SERVICE BULLETIN

APPLICABILITY: 2019-23MY Forester

**NUMBER:** 07-218-23 **DATE:** 02/10/23

SUBJECT: Genuine Alternative Battery Replacement

**Remaining Height Is More Than 2mm**

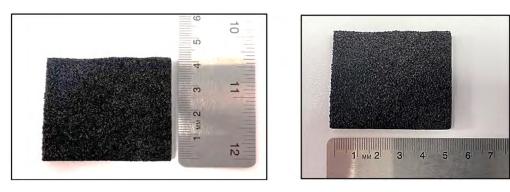
**A. CAREFULLY** cut off and trim the two protrusions on the bottom of the battery tray. This will allow a more streamlined fit when installed on the vehicle. Try to make the cut as flush as possible.

**CAUTION:** Be sure the protrusions are trimmed flush. The remaining protrusion height MUST be less than 2mm to provide proper fitment.

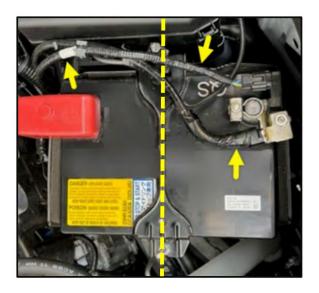
**STEP 4:** Install the NEW battery cover (**p.n. 82123AN000**) to the alternative replacement battery. Confirm the bottom of the cover is aligned flush with the bottom of the battery.
